May 9, 2023

ADDENDUM NO. 1

RE: Item #1, May 17, 2023 Letting - NH 0018(157)438, PCN 6923, Lincoln County - Grading, PCC Surfacing, Asphalt Concrete Surfacing & Replace Str RCBC (2 - 9'x5' Precast or CIP; 2 - 12'x5' CIP RCBC)

| STATE OF SOUTH DAKOTA | PROJECT NH 0018(157)438 | SHEET NO. B38 | TOTAL SHEETS B139 |

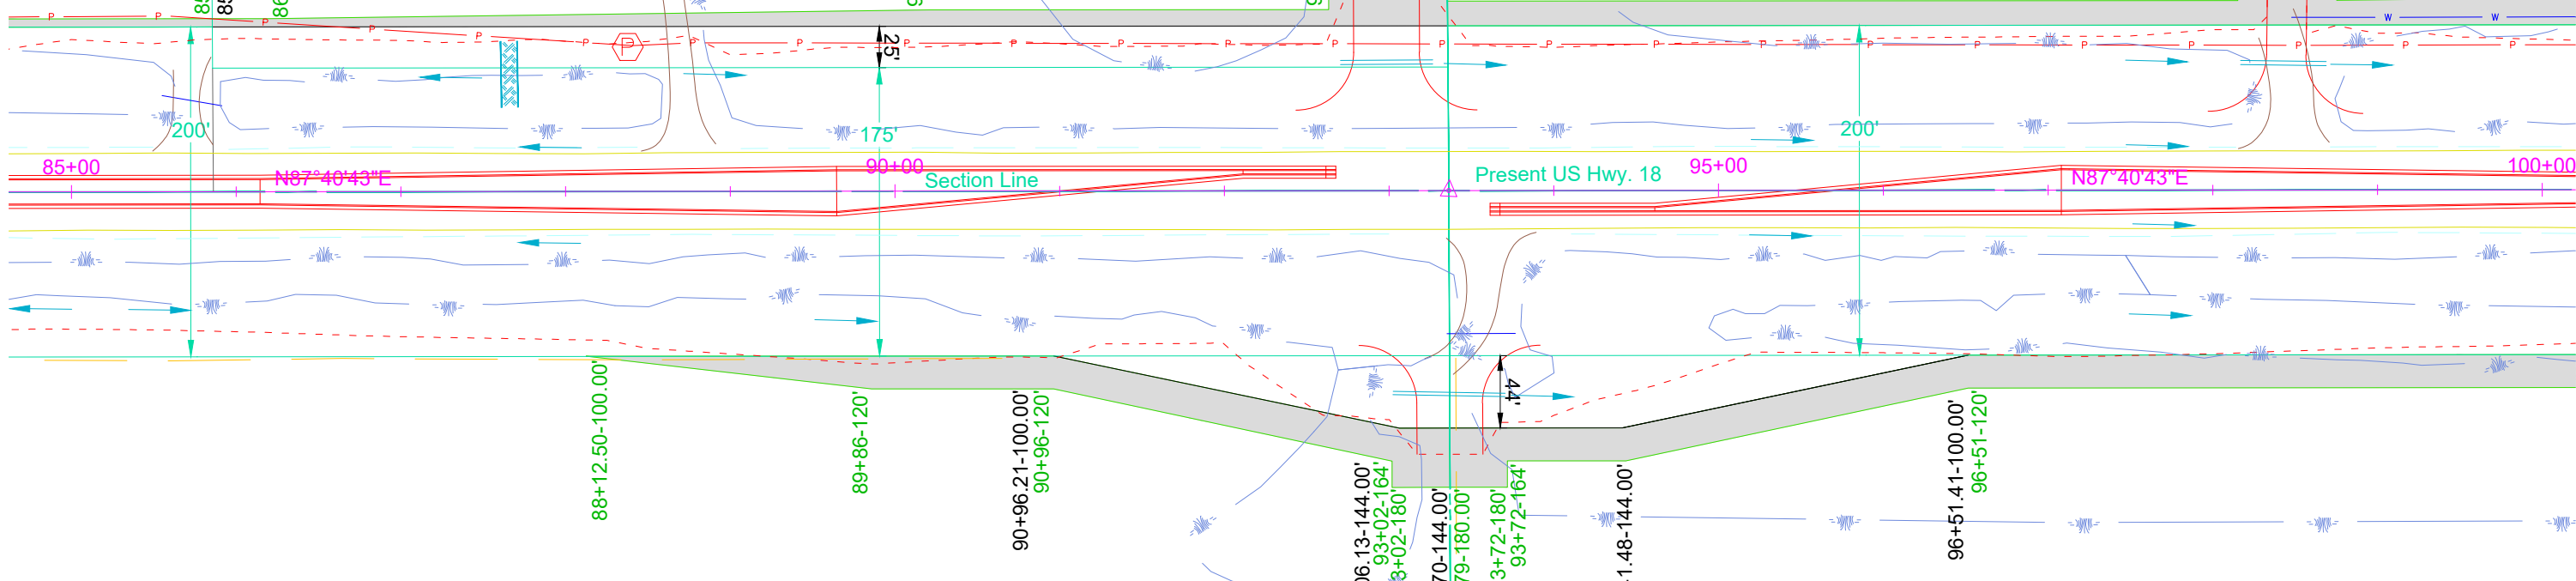
- Sheet B23-B27:** PROPOSED US HIGHWAY 18 TYPICAL SECTIONS were revised.
- Sheet B38:** Permanent fence on Parcels 2 and 5 was removed.
- Sheets B46 & B47:** Sta 148+00 Junction Box was revised.

| STATE OF SOUTH DAKOTA | PROJECT NH 0018(157)438 | SHEET NO. B52 | TOTAL SHEETS B139 |

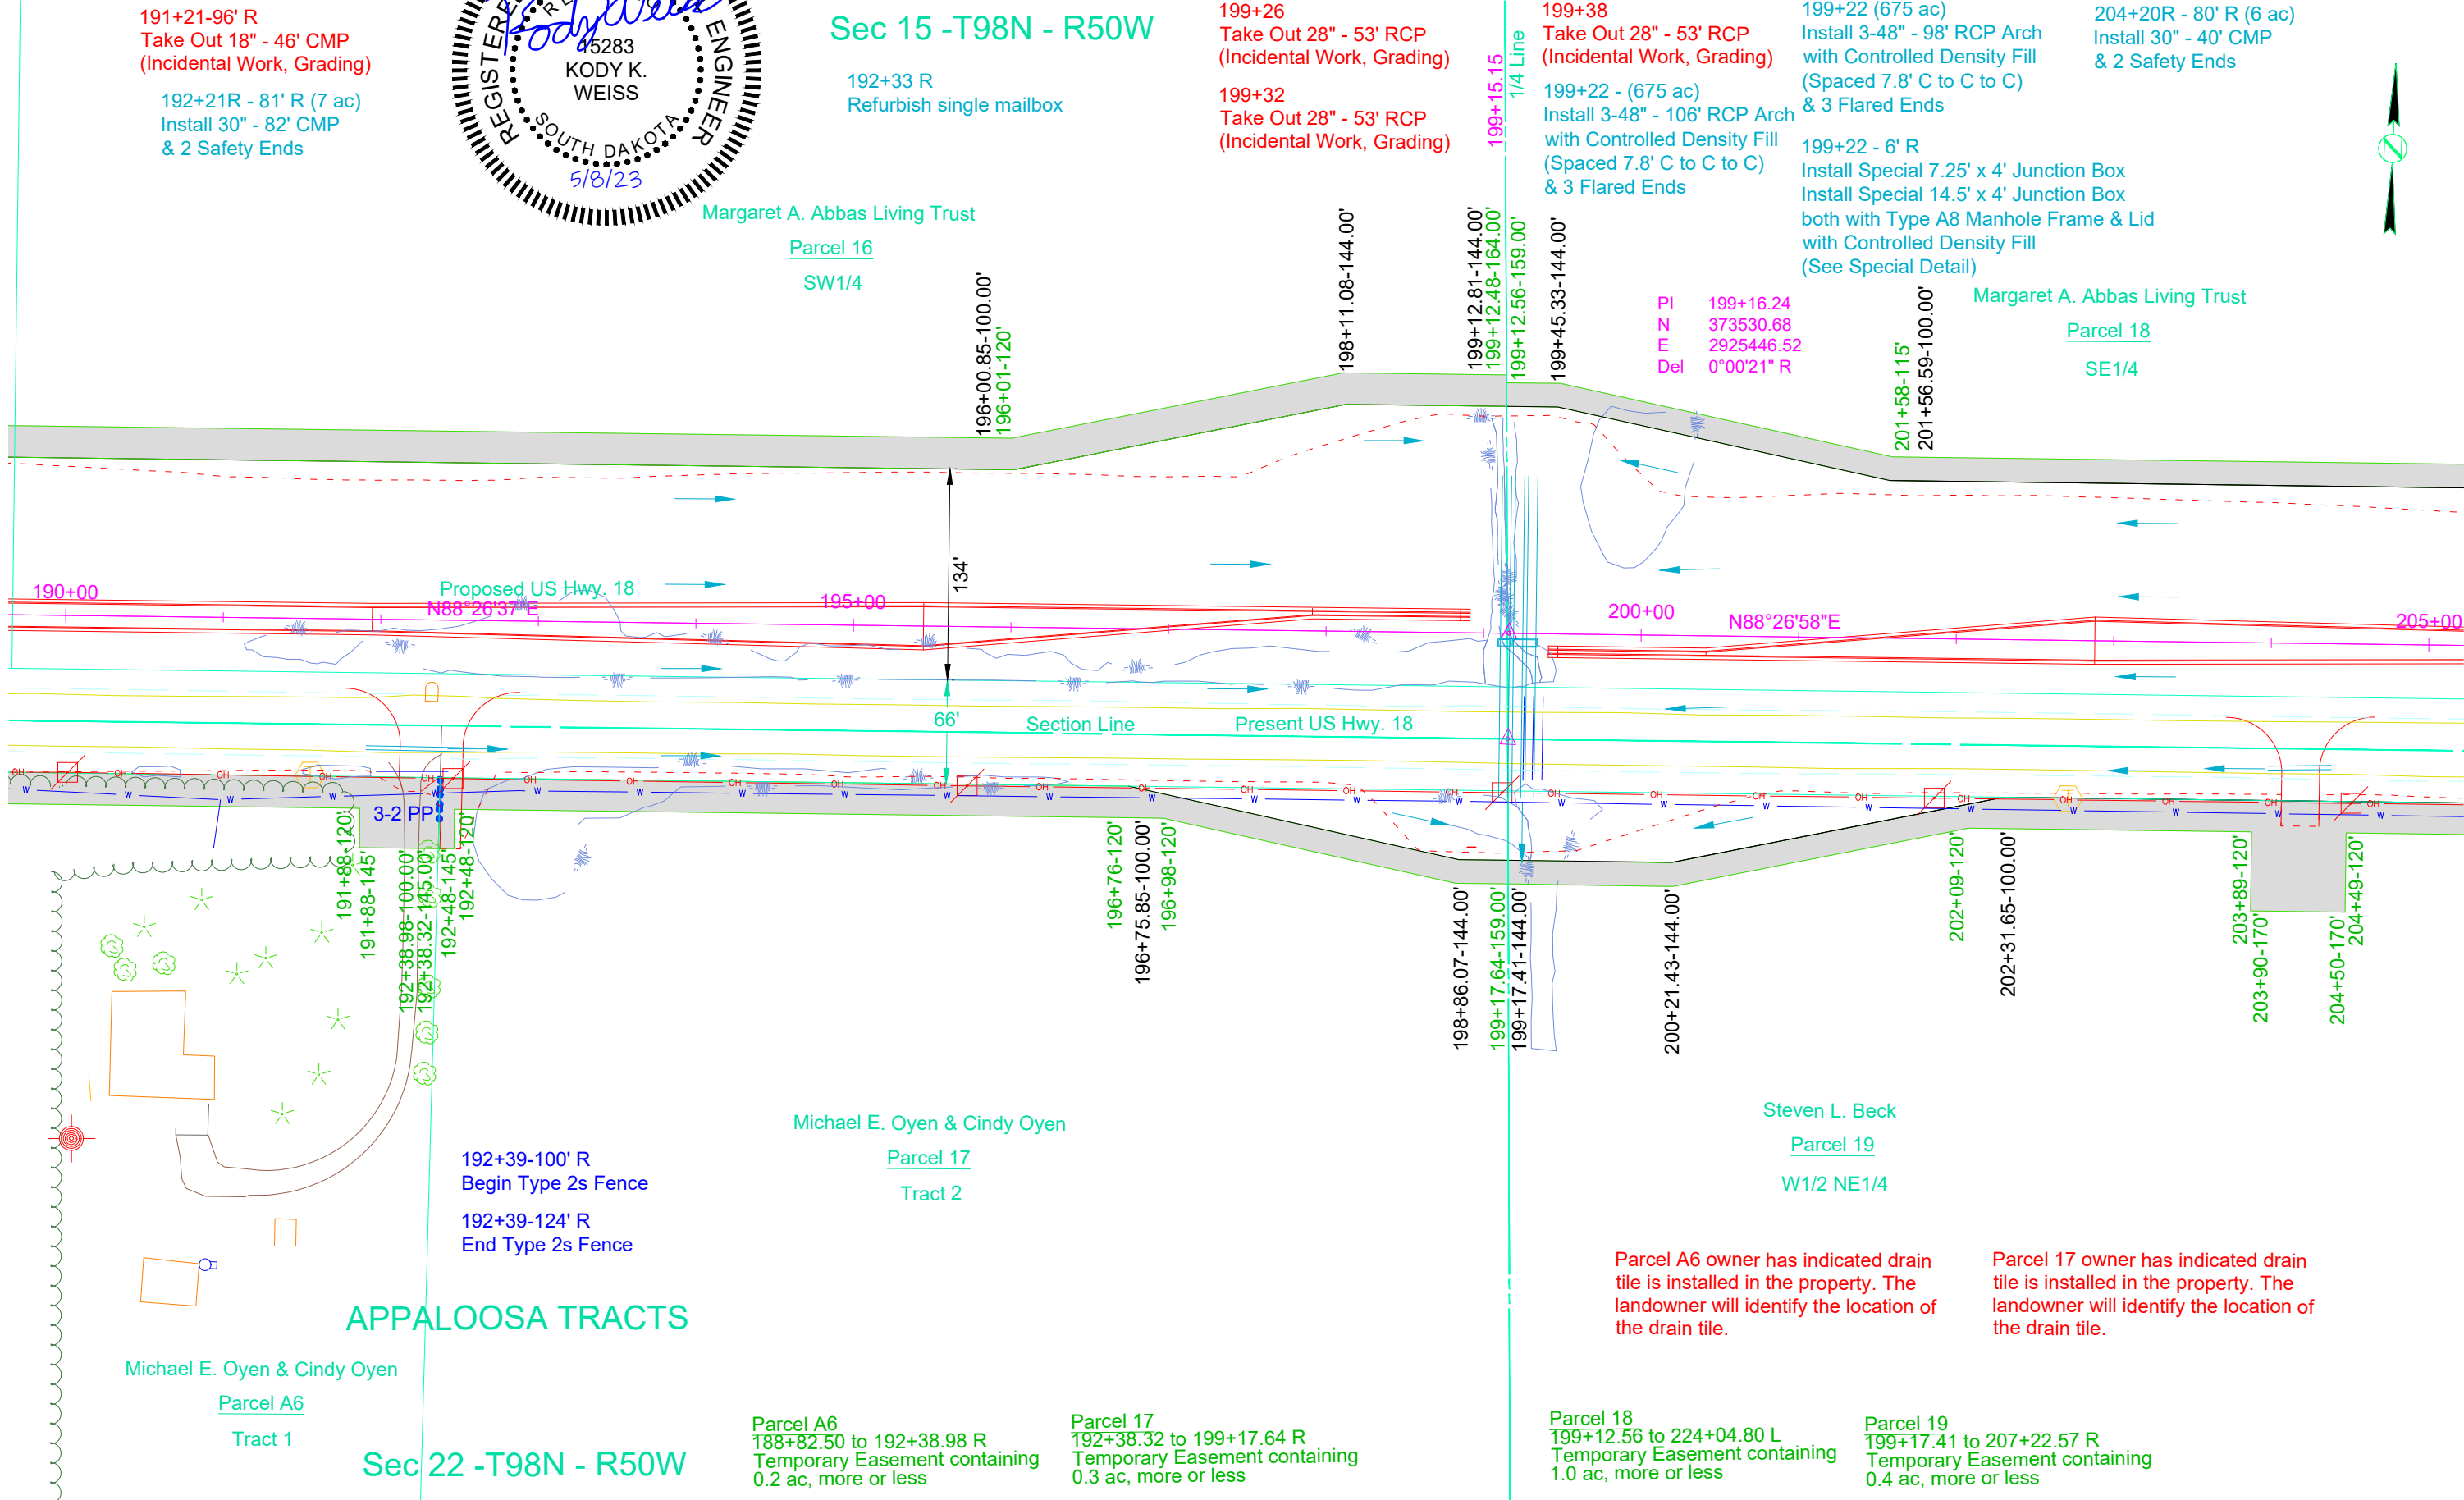
- Sheets B52 & B53:** Sta 199+22 Junction Box was revised.
- Sheets B56 & B57:** Sta 226+50 Junction Box was revised.
- Sheet B58:** Plug Existing Well at Sta 238+99-86'L (Incidental Work, Grading) note was added.

| STATE OF SOUTH DAKOTA | PROJECT NH 0018(157)438 | SHEET NO. B66 | TOTAL SHEETS B139 |

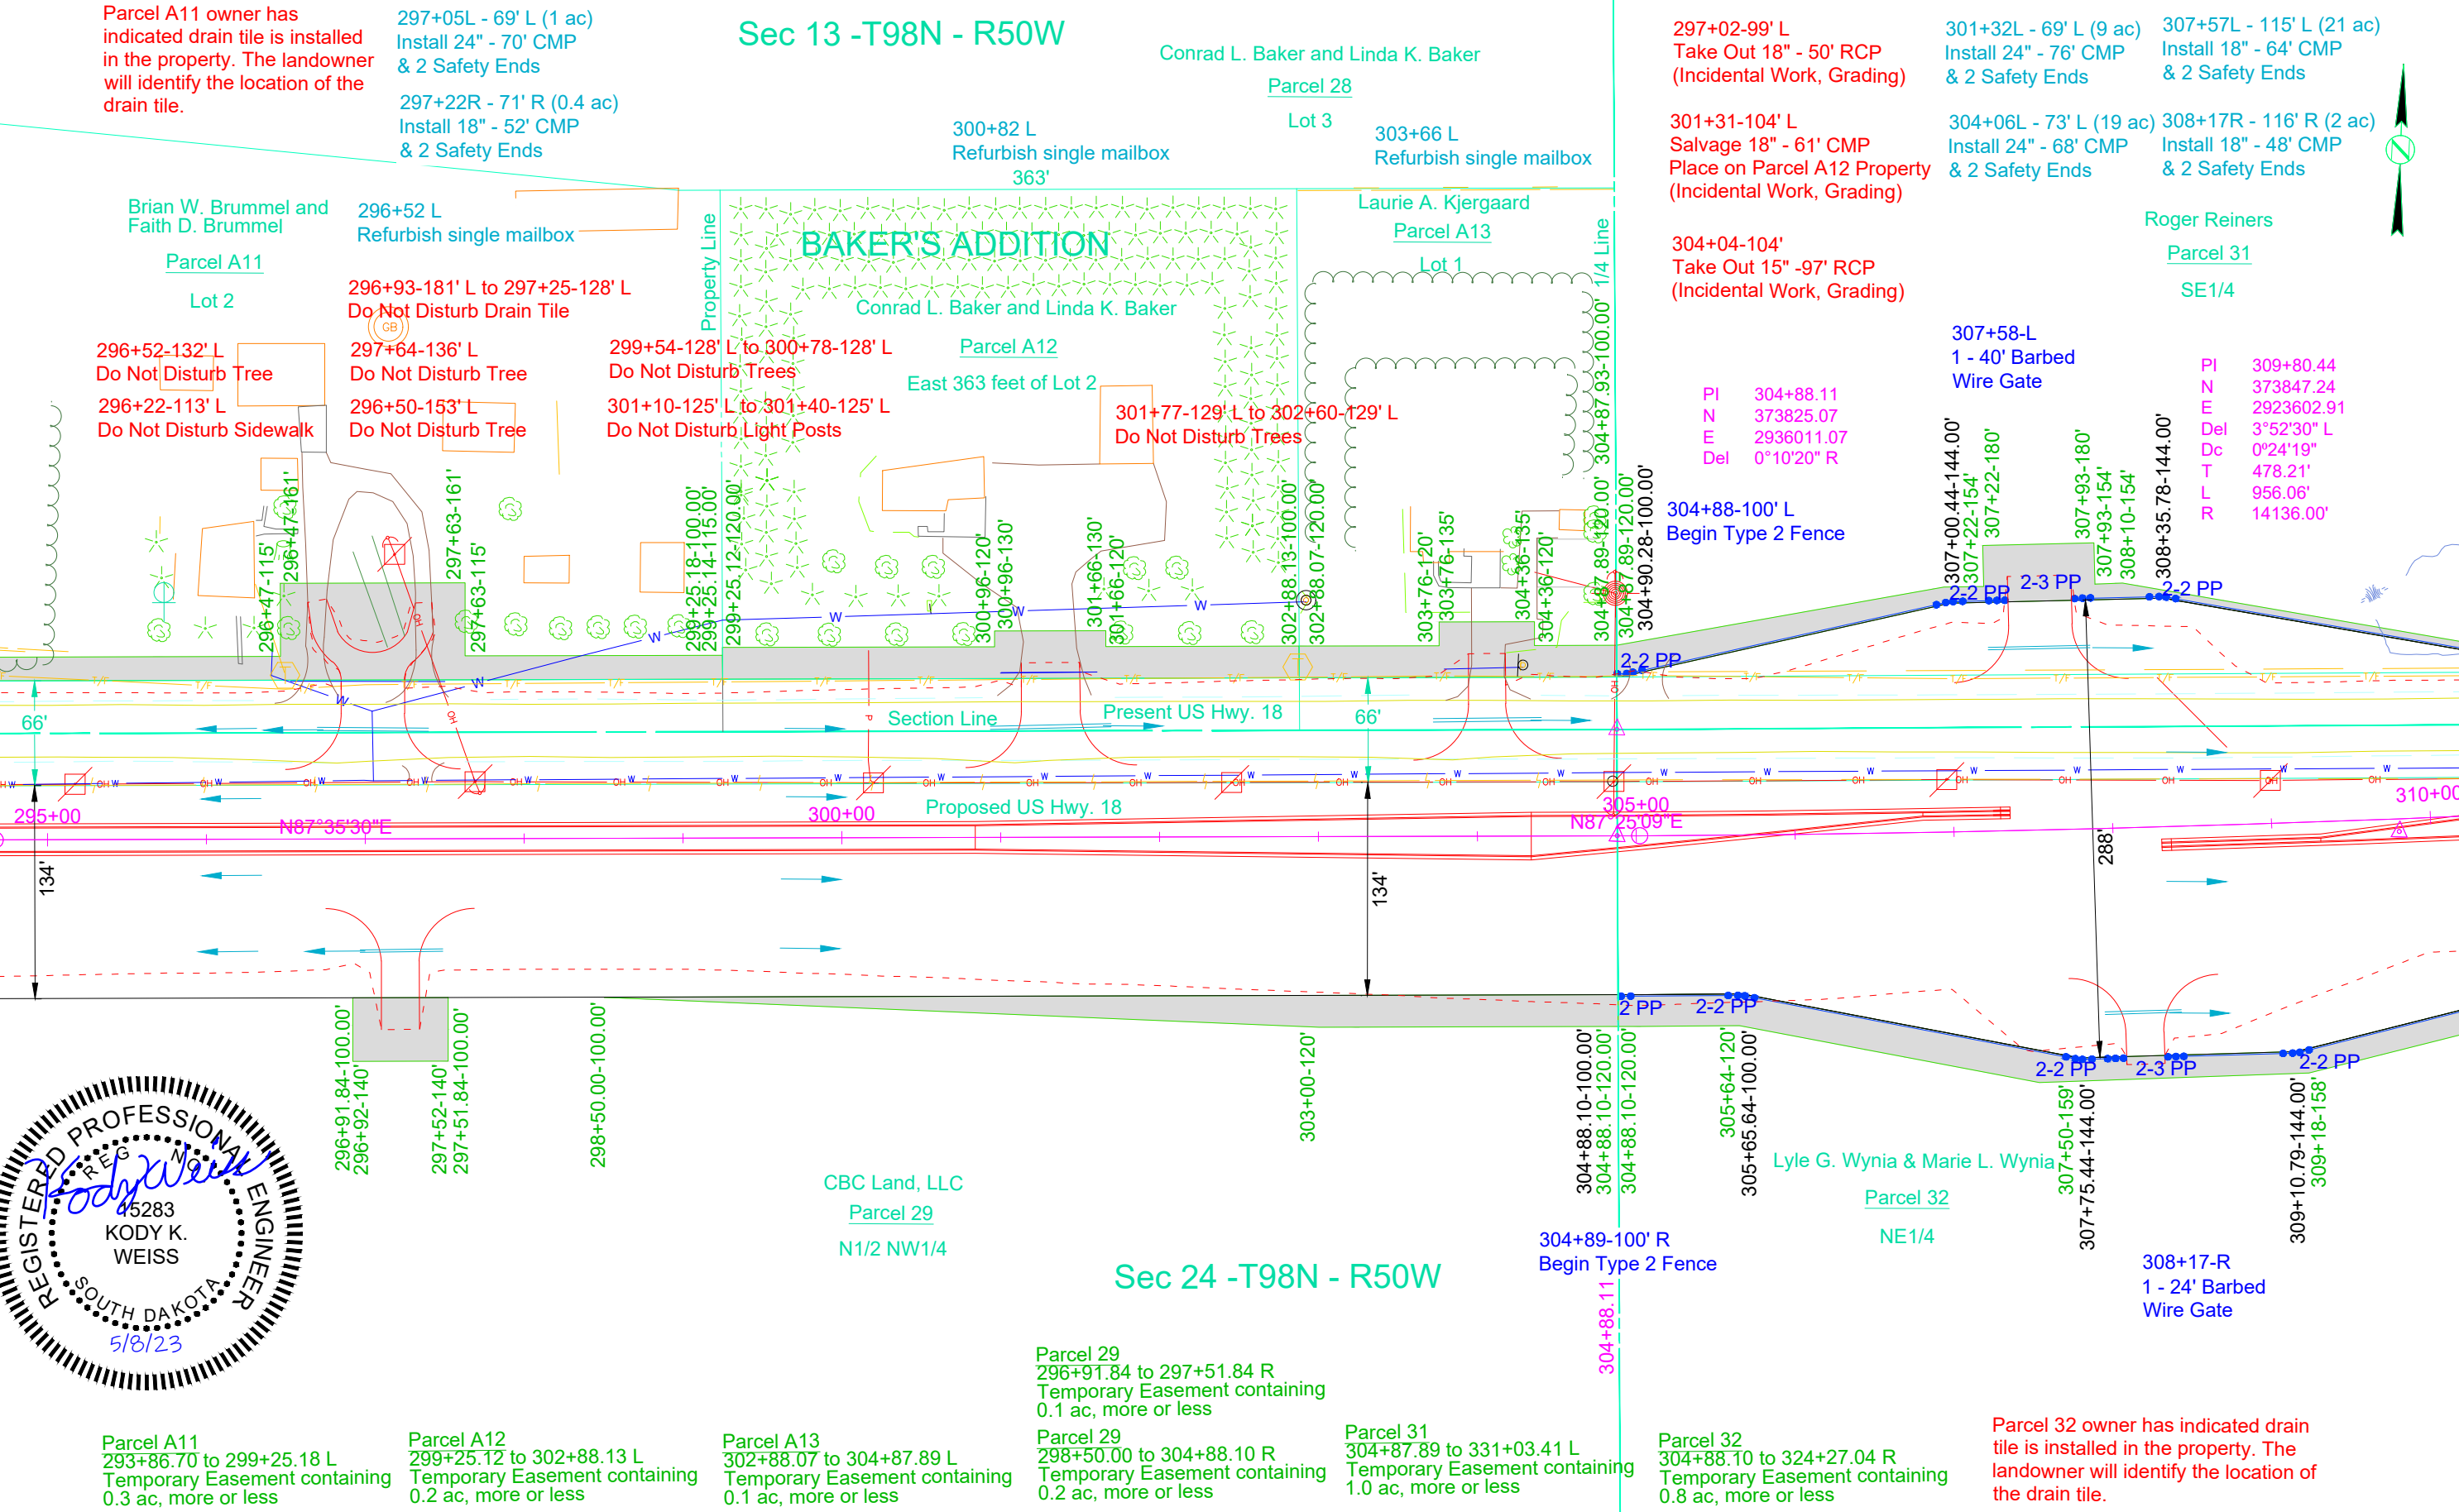
- Sheets B66 & B67:** Added approach at 308+17R, and revised fencing and pipe to accommodate approach entrance.
- Sheets B68-B70:** Fence, curb and gutter and drop inlet adjacent to parcel 33 were revised.
